SUBMISSION FROM ROSE BAY RESIDENTS ACTION GROUP (RBRAG)**FORMAL OBJECTION TO SSD – 86017721, 23-31 DOVER ROAD, ROSE BAY****30 NOVEMBER 2025****INDEX**

SSD-86017721 23-31 Dover Road, Rose Bay proposes an 8-storey tower with two levels of deep basement excavation (approx. 7–8 m) in the **Rose Bay Settlement Area—a location formally mapped in Woollahra Municipal Council’s (“Council”) Development Control Plans (“DCP”) (Chapter E2) as high-risk** for groundwater, geotechnical instability and flooding. The Proponent’s own reports confirm very loose marine sands, a shallow and tidally influenced aquifer, high-permeability soils, and H5–H6 flood hazard immediately across the site frontage.

Plate 4-2: Depth of Expected Groundwater Drawdown at Various Distances From the Excavation Boundary

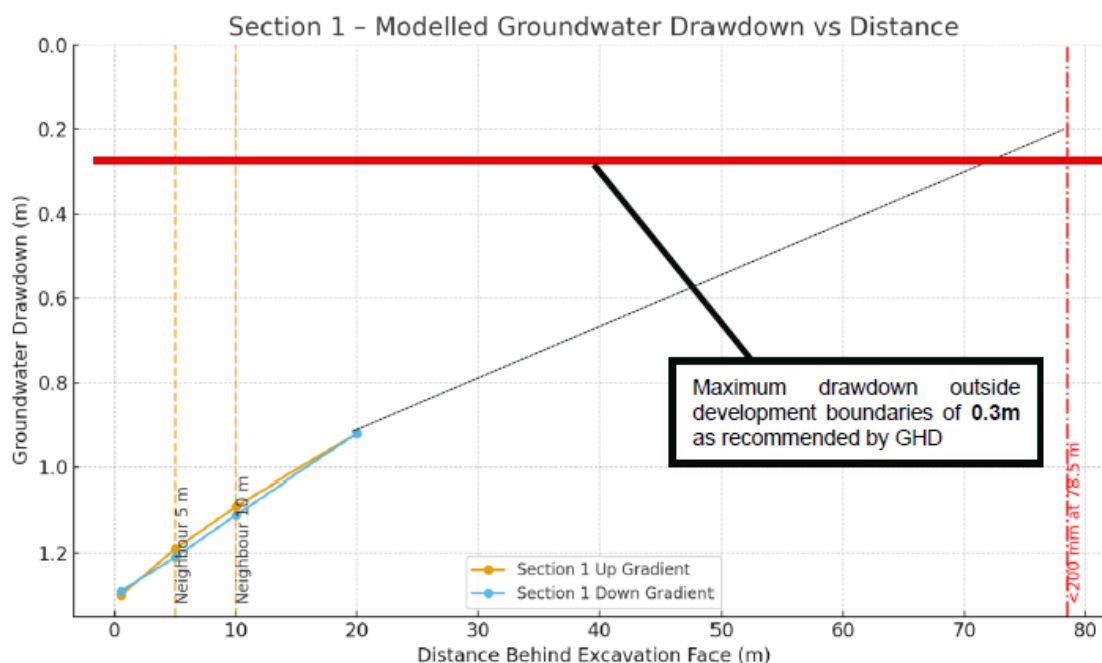
The results demonstrate that the groundwater drawdown exceeds the limit of 0.3m imposed by the local DCP. The breach extends 75m from the boundary of the excavation site. The GHD (2020 and 2024) reports predict that a drawdown in excess of 0.3m in this area will expose properties in that zone to subsidence, settlement and damage. The independent report calculates **40 properties (including blocks of apartments, hence**

the number of homes is higher) are put at significant risk of damage from this single SSDA alone as shown below [extract from(Fortify 2025) report]:

Below – map illustrating material EIS omissions of pipeline LMR properties

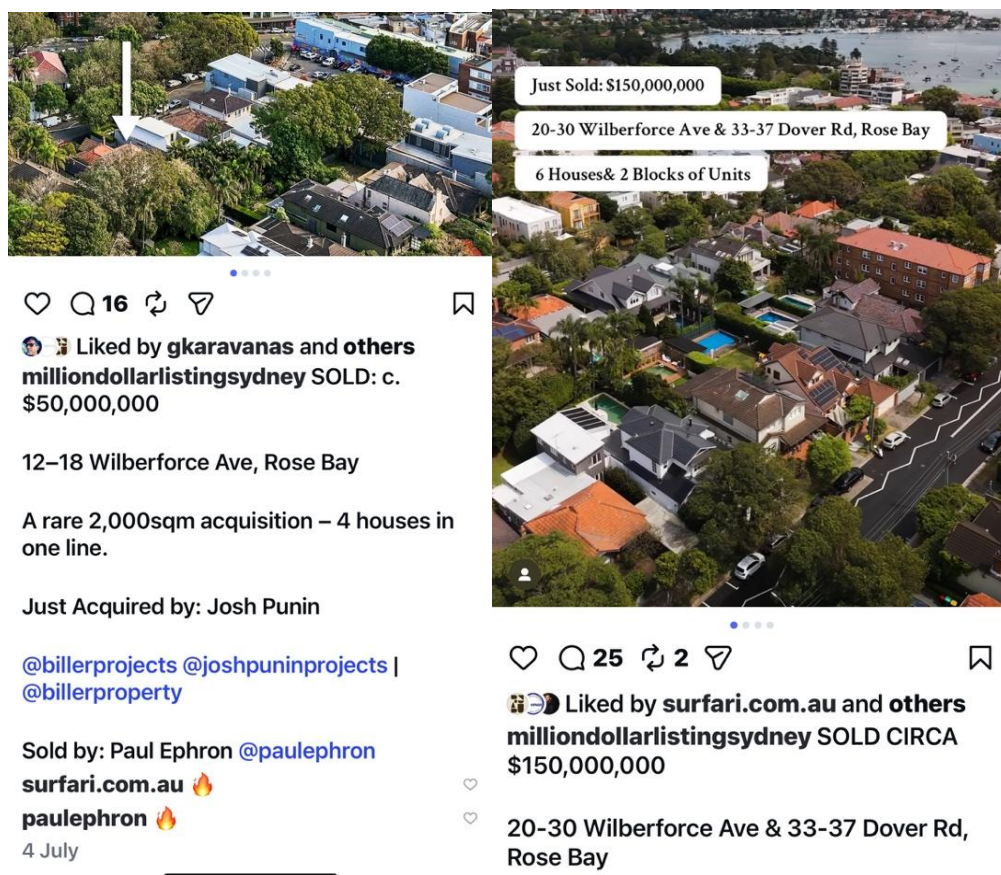
The absence of such information is crucial to any reliance on the expert reports provided in support of the application.

Above: Both immediately adjacent sites (side and rear) were OMITTED from EIS.
